## ADDENDUM NO.3

### VA ROSEBURG HEALTHCARE SYSTEM SEISMICALLY UPGRADE BUILDING 7

May 29, 2015

# TYPICAL STARTER MCC DIAGRAM

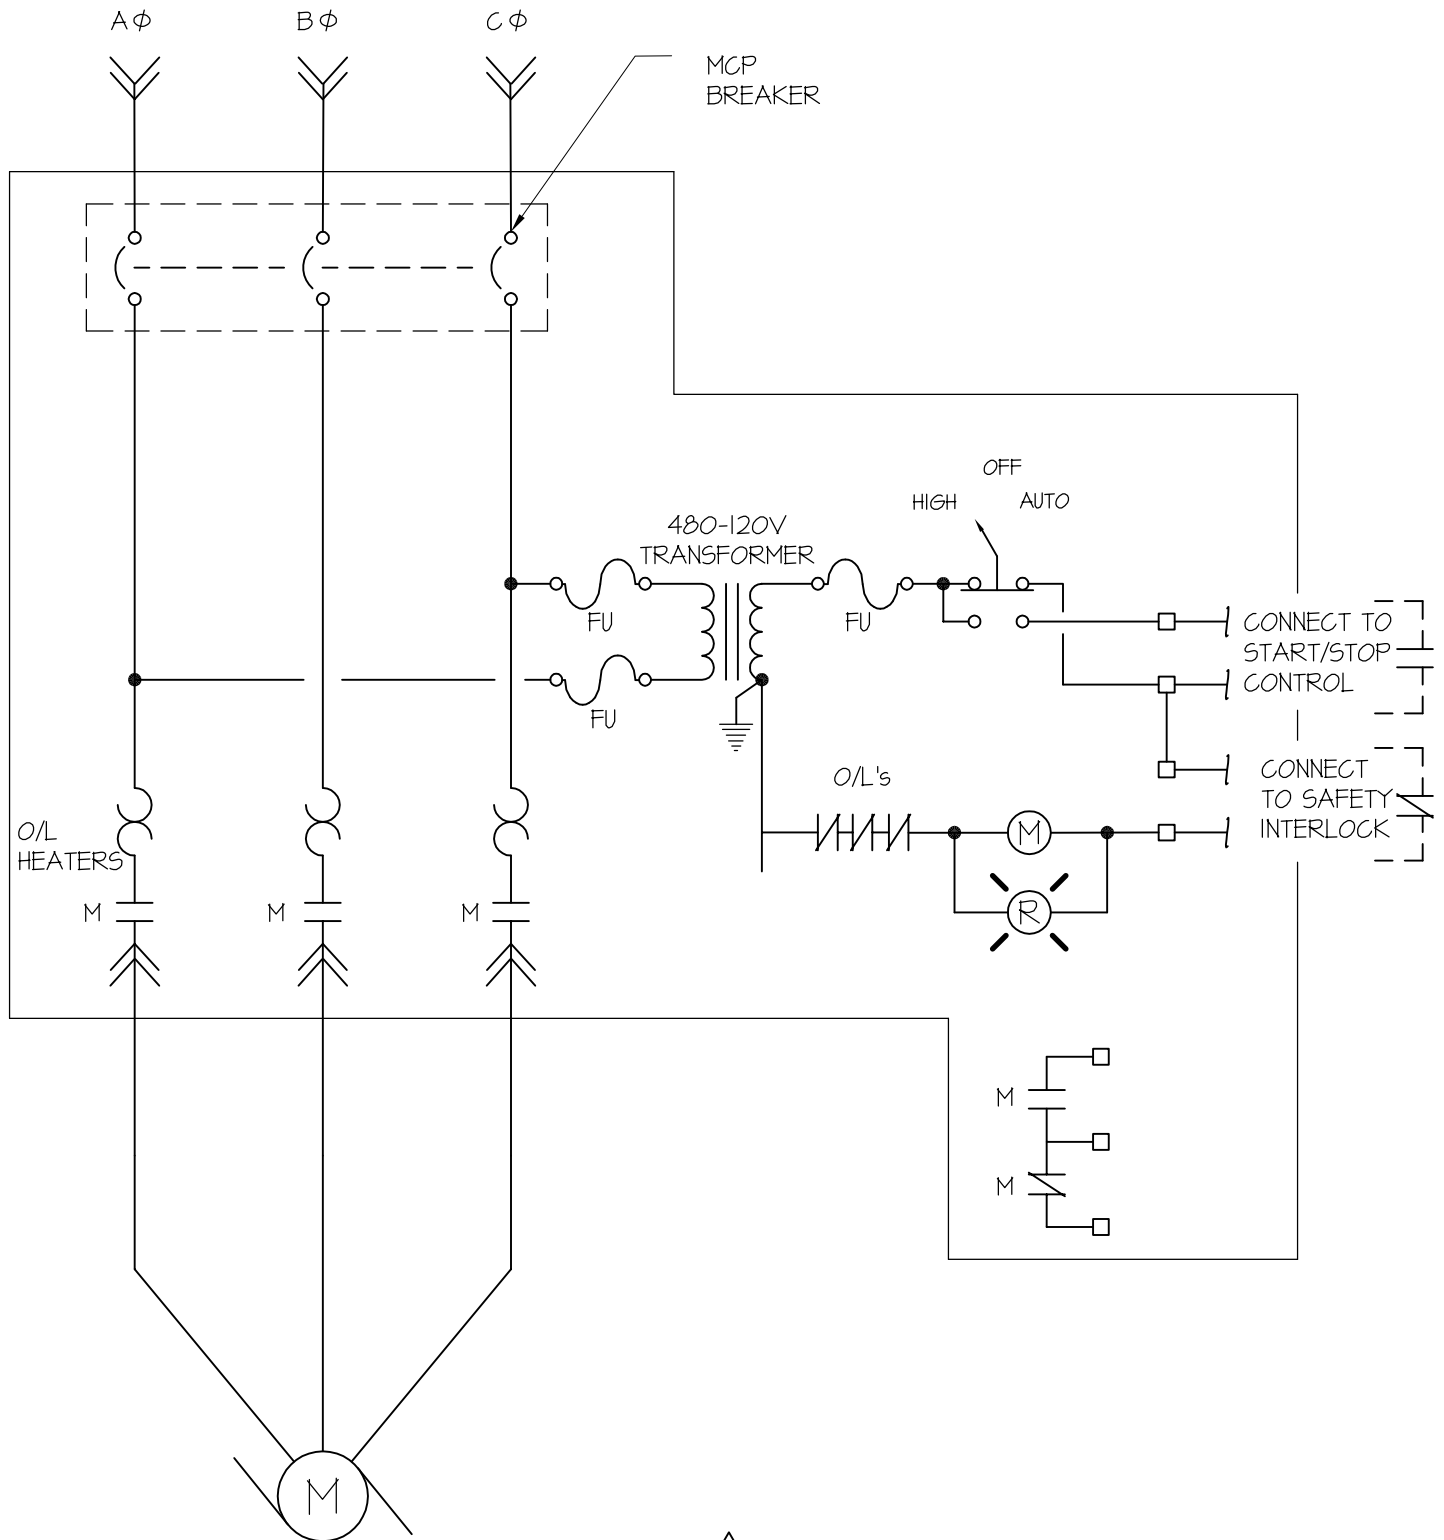
**Item-7 Sheet E-603 ONE-LINE DIAGRAM**

**Add** the following motor control starter wiring diagram indicated on revision drawing 2/E-603 (attached).
